TO: Jeremy Tyler JT
FROM: Michael Eaton ME
DATE: September 20, 1990
SUBJECT: Trail Ridge Landfill, Inc.
DER #161821182

Reference: Trail Ridge Landfill Plan "A"
ET&M NO. E89-113

Reference: Trail Ridge Landfill Plan "A" - Class I and Class III
Request for Additional Information
FDER # 184444
ET&M NO. E89-113-9

REFERENCE: TRAIL RIDGE LANDFILL - PLAN "A"

FIG. 8.27. Positioning of gas extraction well for complete overlap: (a) triangular array; (b) hexagonal array. Solid circles indicate locations of gas extraction wells.

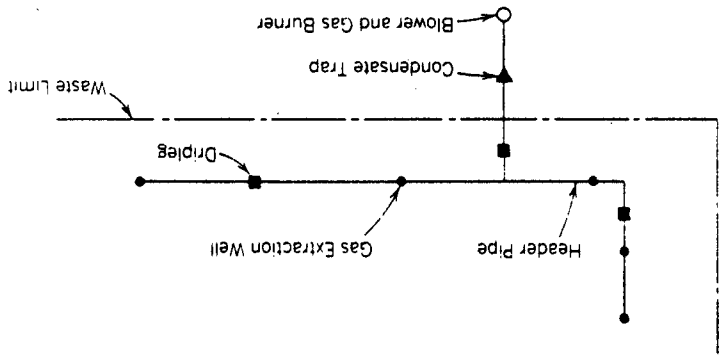
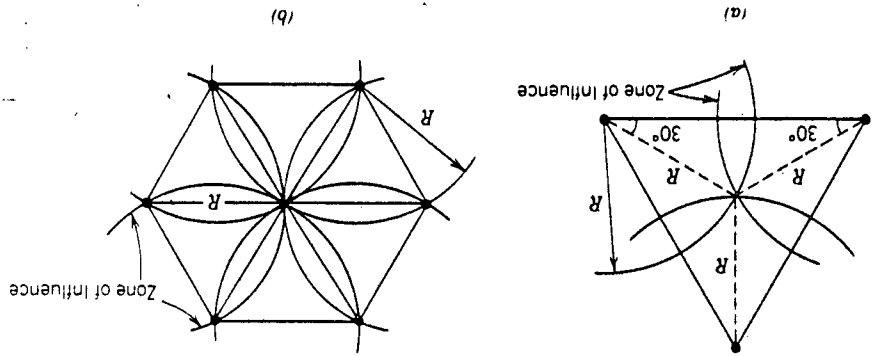
QUESTION 3: Please justify using a 300-foot zone of influence for gas vents instead of the 300-foot centers that the Department normally requires.

RESPONSE 3: A 300-foot hexagonal array provides a 100% overlap versus a 60% overlap for 300-foot centers. (see attachment)
